DELEGATED APPLICATION REPORT

App Ref: PL/24/1353 Full planning permission

Address: 7 BLAGRAVE STREET, READING, RG1 1PJ

Proposal: Demolition of the existing building (façade retained) and erection of a five-storey building with a café, bed and breakfast, and ancillary spaces

New Proposed Front
Elevation

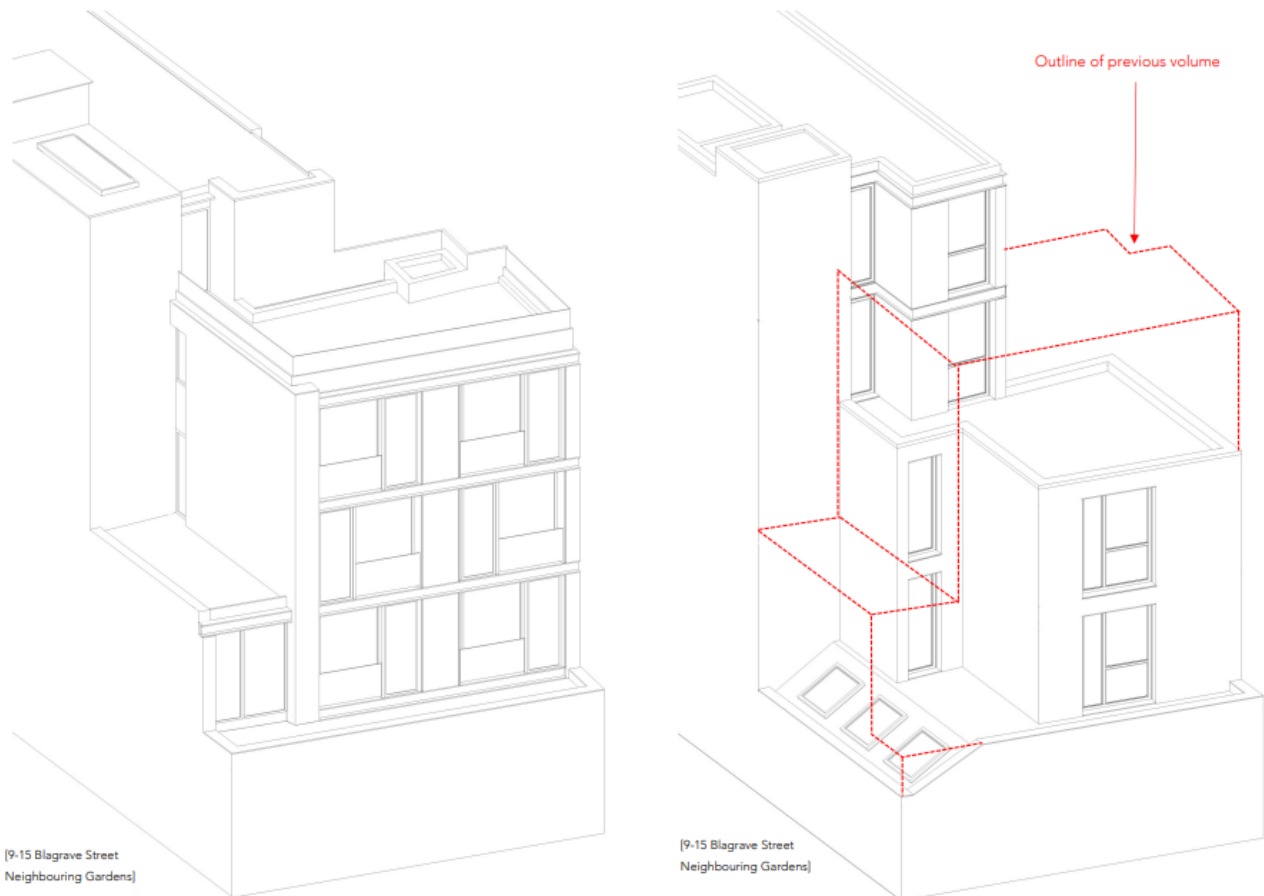
In the context of the previously refused and withdrawn applications, the revisions made to the proposed design are not considered sufficient to address the fundamental concerns with respect to the harm to the character of the site, the appearance of the conservation area, and the setting of the Grade II/II* listed Museum and Town Hall. The contemporary replacement property would introduce large areas of glazing to the front façade, unbalanced when compared to the fenestration pattern of the neighbouring properties on either side (regardless of the finished floor levels). This results in a disorganised facade appearance, which is disproportioned in comparison to adjoining properties. The loss of the recessed entry way at the ground floor level is also considered harmful to the legibility of the heritage asset. The proposed scale of the development is also imposing on the retained original façade, diminishing its significance and contribution to the character of the conservation area, as the additional three storeys, despite the setback, would appear dominant and excessive, irrespective of the neighbouring buildings.

Overall, the proposed development due to its height, scale and façade organisation would be unproportioned and imposing on the application site, the loss of the property resulting in harm to the appearance of the conservation area and the setting of the Grade II*/II listed Museum and Town Hall.
